The Parish Councils of Assington, Bures St Mary, Leavenheath, Little Cornard, Polstead & Stoke by Nayland

Further written comments on Cable Sealing End Compounds following Bramford-Twinstead (EN020002) Issue Specific Hearing 4

Appendix 1: view of potential access routes taken from Pitmire Lane near Daws Hall

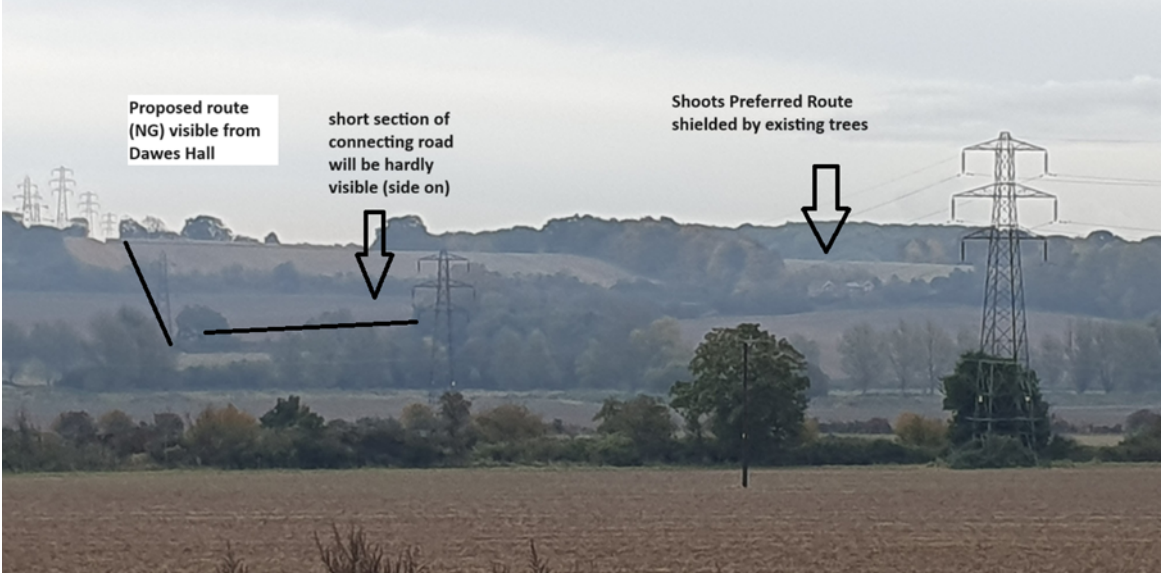
- 2.1 During ISH4 we referred to the high level of visual impact from the proposed permanent access road to the CSEC as proposed in APP-018 sheets 19 & 20. Our concerns focus on the visibility of the road from the Daws Hall area (TL 88764 36643) as shown in Appendix 1.

- 2.3 The proposed permanent access road creates a new junction on the B1508 and crosses a currently completely undeveloped area, which is highly visible from the opposite side of the Stour valley.

- 2.4 While we believe that the undergrounding of Section F could be comprehensively justified in order to reduce the proposed development's impact on both the Dedham Vale AONB and the Stour Valley Project Area, in the event that undergrounding is not pursued, we propose an alternative route for the CSEC access (locations mapped in Appendix 2): using an existing junction to the south of the one proposed at TL 89910 36603, passing two houses then using existing track all the way. The access is serviceable in terms of splay onto the B1508.

- 2.5 In our view, this alternative is preferable for three key reasons:
 - 2.5.1 Visual impact is greatly reduced: the track already exists, and is well hidden by mature hedge and trees from the other side of the valley. Views from the Little Cornard area of the B1508 and Spout Lane would be less impacted than by a new road through a field, and the need for a new junction with the B1508 would be removed.
